New Danfoss Valve Mount Plate SB401

The plate to which the Danfoss hydraulic control valve bank mounts and the adjacent area of the crane base on the SB401 family of cranes has been redesigned to allow better access to the valve bank.

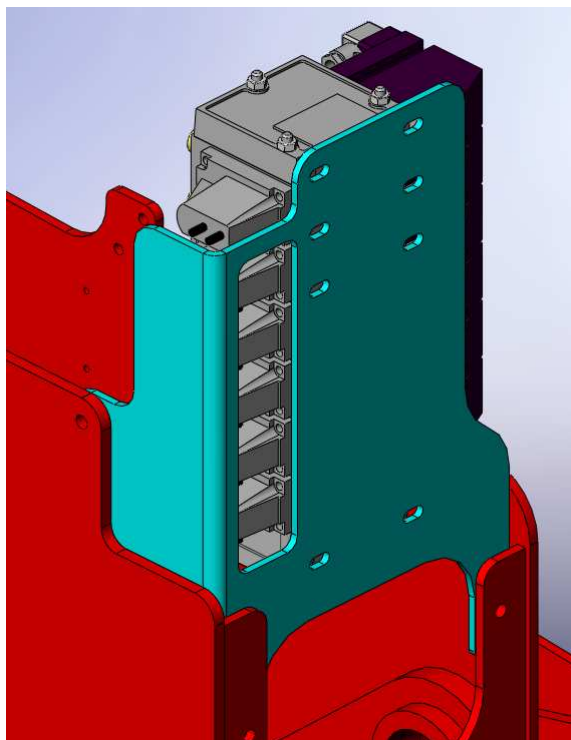
Existing/Old Version

New Version

Plate Mounting Danfoss Valve RH Crane: S8-39734R replaces S8-33620

Plate Mounting Danfoss Valve LH Crane: S8-39734L replaces S8-33633

The reason for this change is to improve serviceability of the SB401 sidelifter. If the mounting plate is removed the spools in the valve bank will be accessible without having to remove the valve bank from the crane. Although the pipes that run to and from the valve bank will hold it in place, it is recommended that a suitable block is positioned below the valve bank to help support it while the mounting plate is not fitted.
